Re: St. Lucie Units 1 and 2
Docket Nos. 50-335 and 50-389
Anticipated Transients Without
Scram (ATWS) Plant Specific Information

In accordance with Florida Power & Light Company (FPL) letter L-86-446, dated November 3, 1986, the plant specific Diverse Scram System Conceptual Design and the plant specific AFAS/RPS Diversity Study are enclosed.

NRC EVALUATION OF CEN-315 SUMMARY OF THE DIVERSITY BETWEEN THE REACTOR TRIP SYSTEM AND THE AUXILIARY FEEDWATER ACTUATION SYSTEM FOR CE PLANTS

FIGURE 6

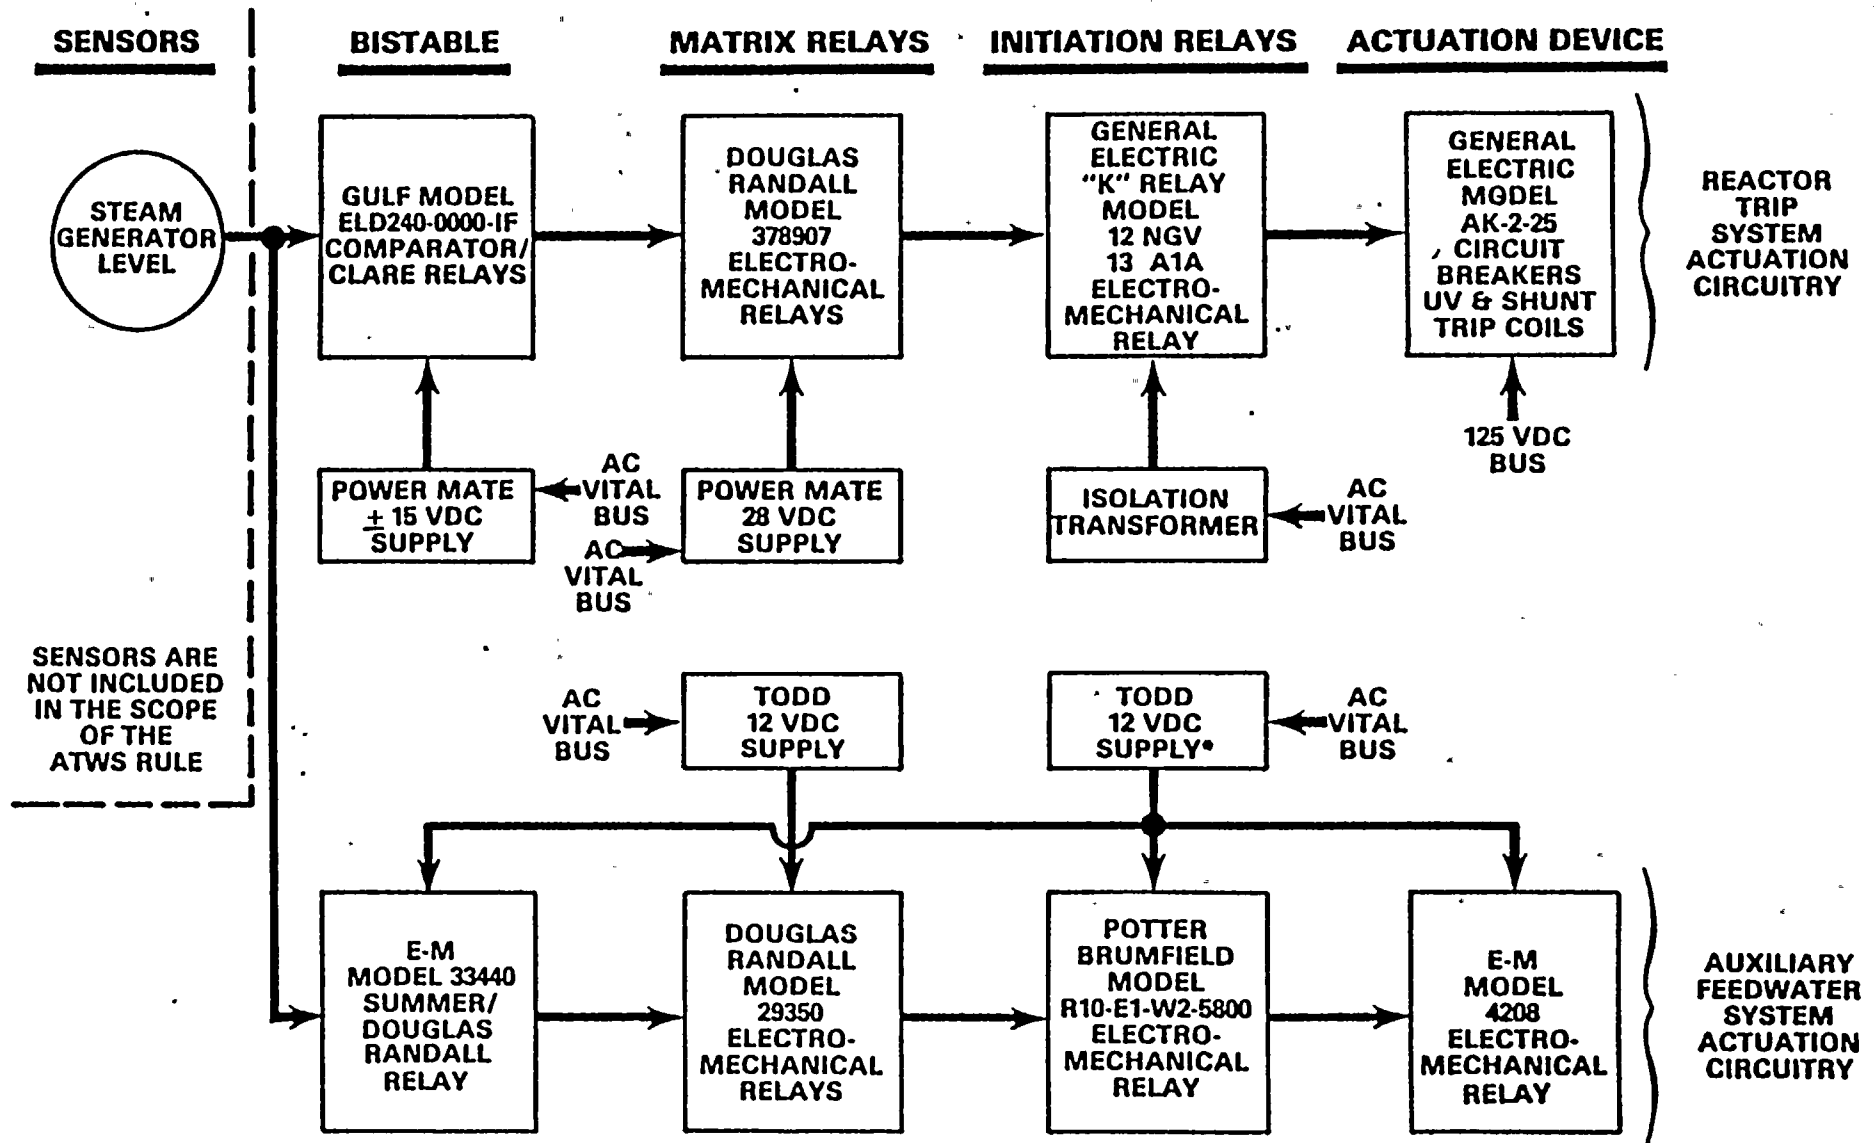
The RPS bistables and associated DC power supplies are from different manufacturers than the AFWS bistables and power supplies. Both the RPS and AFWS matrix relays, however, are Douglas Randall electromechanical (reed switch) relays. The relays have different model numbers and the associated power supplies are from different manufacturers and have different voltage ratings. The RPS and AFWS initiation relays are both electromechanical relays, but are from different manufacturers. The associated power supplies are also from different manufacturers and use AC versus DC power. The final actuation devices are from different manufacturers, and use different power supplies and principles of operation.

CEN-315 claims that although the matrix relays have the same manufacturer and design principle, since they are different models and have different DC power sources, that an adequate level of diversity exists between the two systems. The staff can not reach a conclusion regarding the acceptability of diversity between RPS and AFWS matrix relays based on the information provided. The differences in the physical and operational characteristics of the two models must be analyzed to determine the potential for CMF mechanism affecting the two models.

The RPS and AFWS bistables, initiation relays, and actuation devices appear to be sufficiently diverse to satisfy the diversity requirements of the ATWS rule. The plant specific submittal should include additional information concerning similarities and differences between the RPS and AFWS matrix relays and how these factors affect their susceptibility to CMFs.
